BEACH AVENUE
Long Island

STATEMENT ACCOMPANYING APPLICATION FOR BUILDING PERMIT

for shed for storage of wood and coal
at Cor. Beach Ave. & Woodbury St.
Long Island

APPLICATION FOR PERMIT

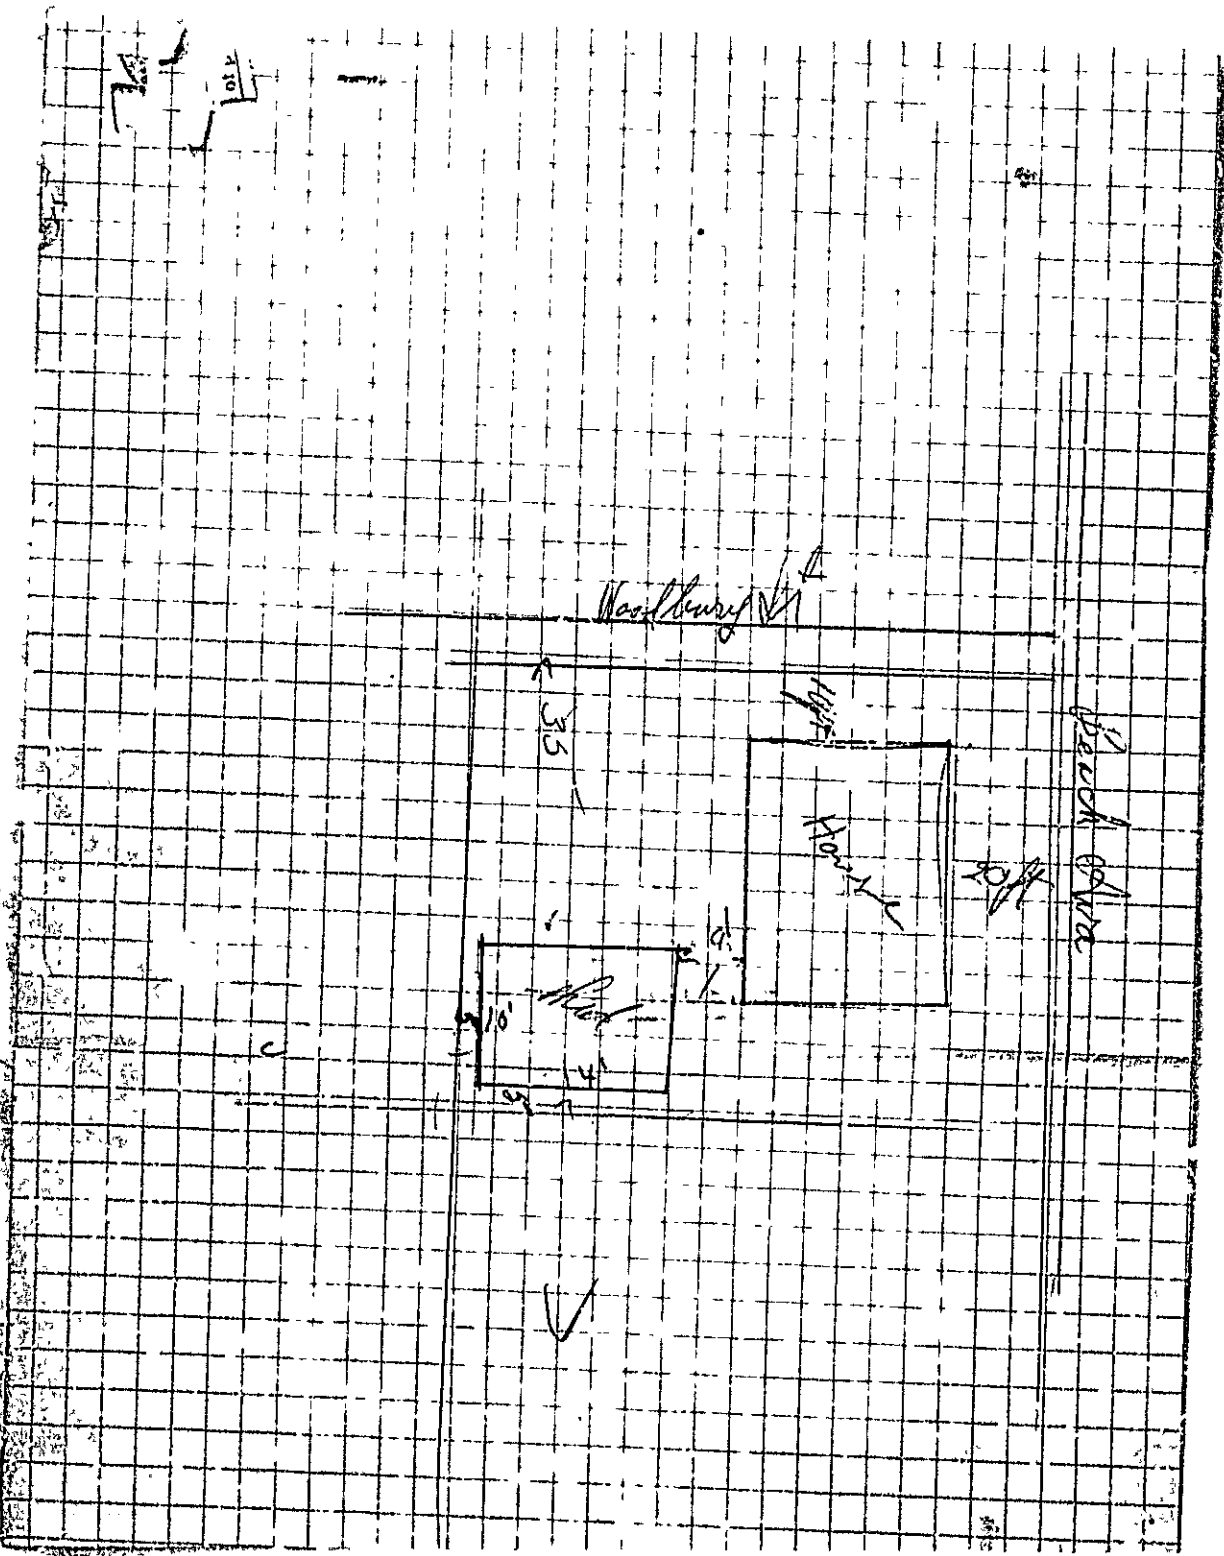
Referring to your application for a building permit to cover construction of a one story shed 10' x 14' for the storage of coal and wood at the corner of Leach Avenue and Woodbury Street, Long Island, the rafters as given on your application are 2x4, fifteen inches from center to center on a ten foot span. If these rafters are to be on a ten foot span, they should be at least 2x6 and may be spaced eighteen inches from center to center. It will be necessary for you to notify this office of your intention to use this size rafters, or equivalent construction, in the roof before the permit is issued to cover the work.

Your location plan shows that the shed is to be at least five feet from either property line. Please see to it that these distances are not less than five feet in any event.

Received your letter of the
15th. as you say that I will
have to use 2 x 6 for Roof, 2 in
& 18 in a foot. That will be
as you say I will do it
